RM240327, RM240328 & RM240329 - Richmond South Low Level Reservoir - Response to Request for Further Information

5-G3445.59

Figure 1: Site Layout Plan

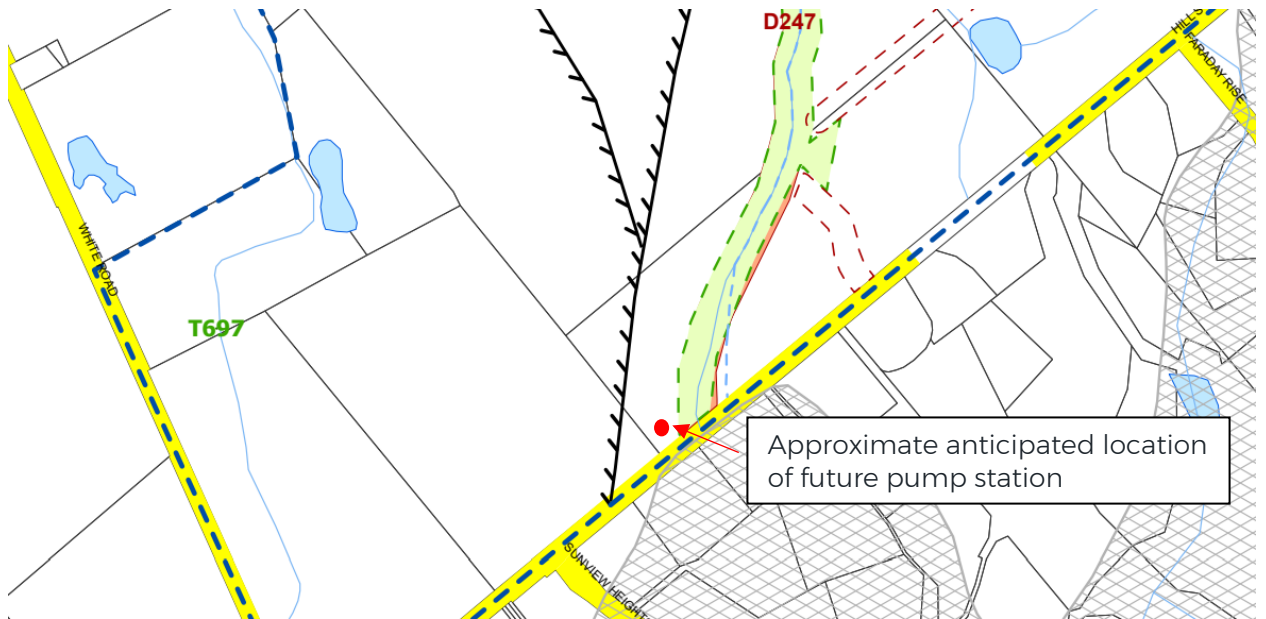
Question 1: *The notice of requirement indicates that flexibility is sought to provide for a future pumping station and the designation is for “water supply purposes”. Details of the size and likely location of the pump station are included in plans, but this is not assessed in the Landscape Assessment. Please provide an addendum to the landscape assessment or memorandum which considers any potential landscape effects associated with this pump station, and whether any further mitigation planting, colour restrictions etc are required.*

Answer: If constructed, it is anticipated that the potential future pump station will be located on the front portion of the property, as indicated on the Site Layout plan submitted with the application and included in Figure 1 below. This anticipated location is below the mapped ridgeline, as shown in Figure 2 below, meaning that the pump station could be constructed in this location as a permitted activity under Tasman Resource Management Plan Rule 16.6.2.1 (Network Utilities and Public Works).
